[Docket No. 98–NM–300–AD; Amendment 39–14355; AD 2005–22–11]

Airworthiness Directives; Mitsubishi Model YS–11 Airplanes, and Model YS–11A–200, YS–11A–300, YS–11A–500, and YS–11A–600 Series Airplanes

ACTION: Final rule.

HUB CRACK - VIEW FROM TOP

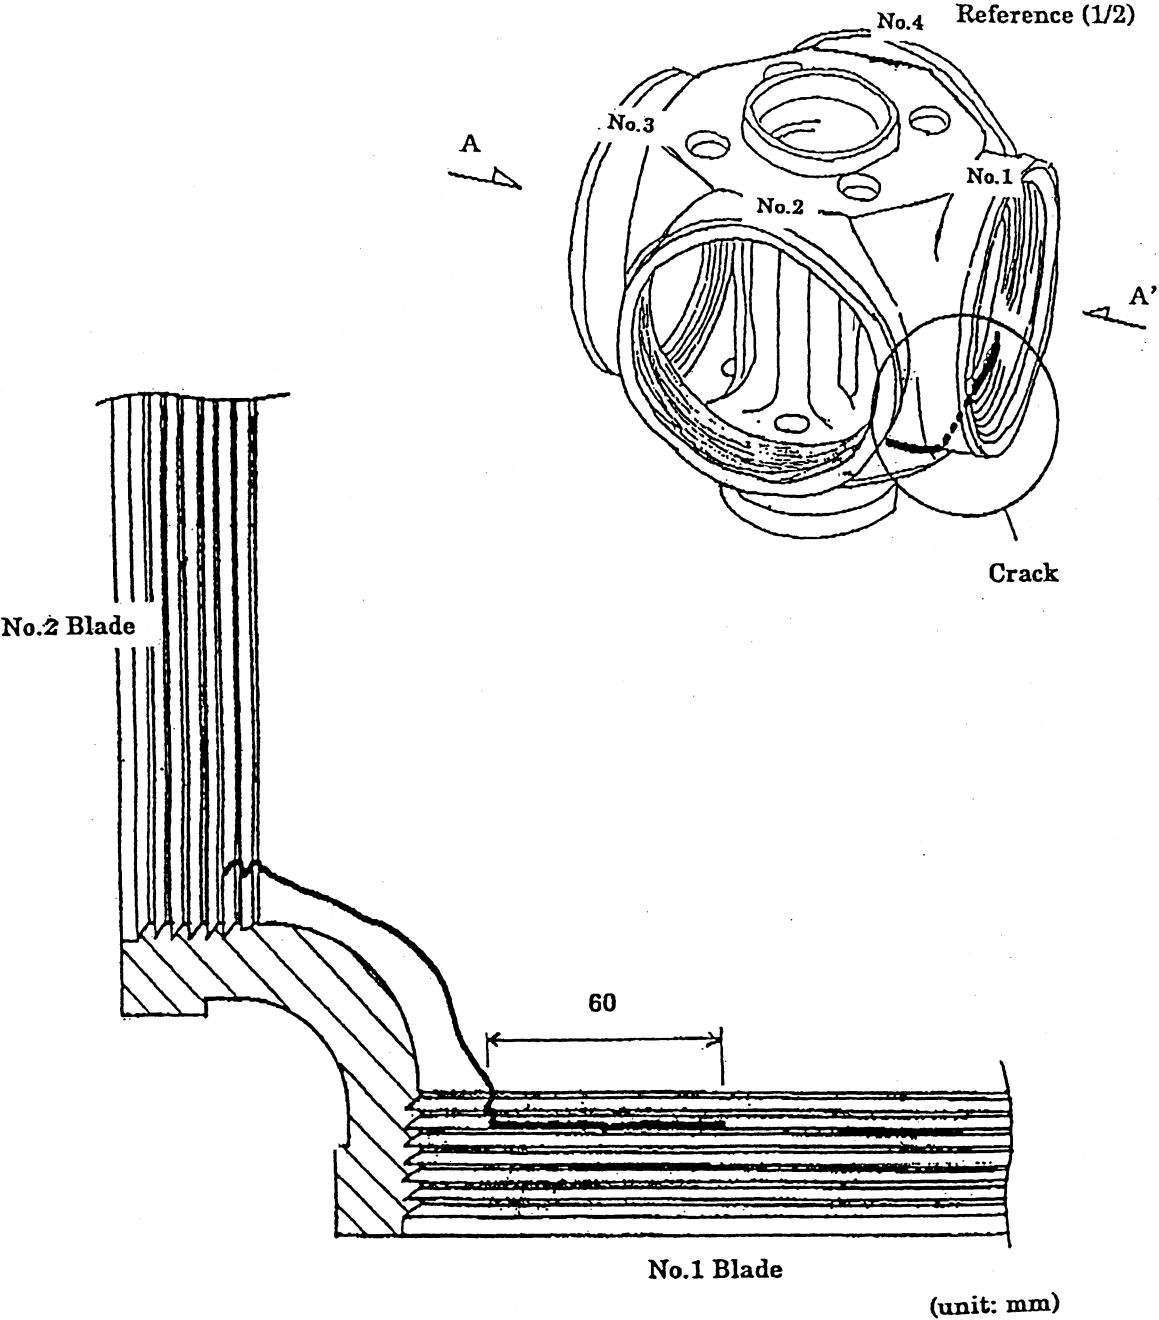
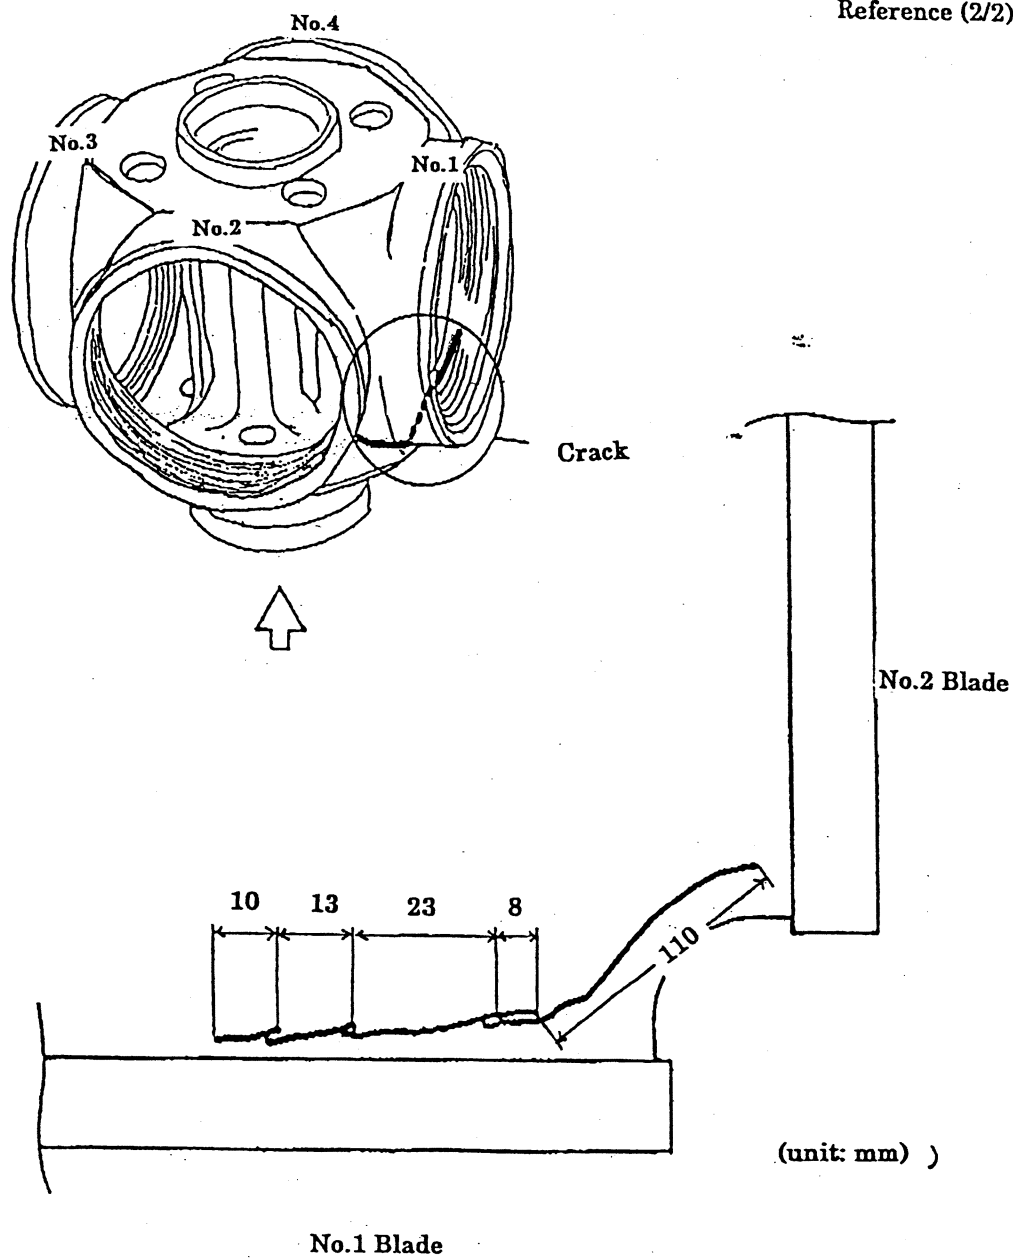
(a) Within 25 flight hours or 30 days after the effective date of this AD, whichever occurs first, remove the spinner and perform a detailed inspection for cracking of the propeller hub in the crack area shown in Figure 1 of this AD.

(1) If no crack is found, repeat the actions required by paragraph (a) of this AD thereafter at intervals not to exceed 25 flight hours.

(2) If any crack is detected, prior to further flight, replace the hub with a new hub according to a method approved by either the Manager, Los Angeles Aircraft Certification Office (ACO), FAA; or the Japan Civil Aviation Bureau (JCAB) (or its delegated agent). Chapter 61 of the Nihon Aeroplane

Manufacturing Company YS-11 and YS-11A Aircraft Maintenance Manuals is one approved method. Repeat the actions required by paragraph (a) of this AD thereafter at intervals not to exceed 25 flight hours.
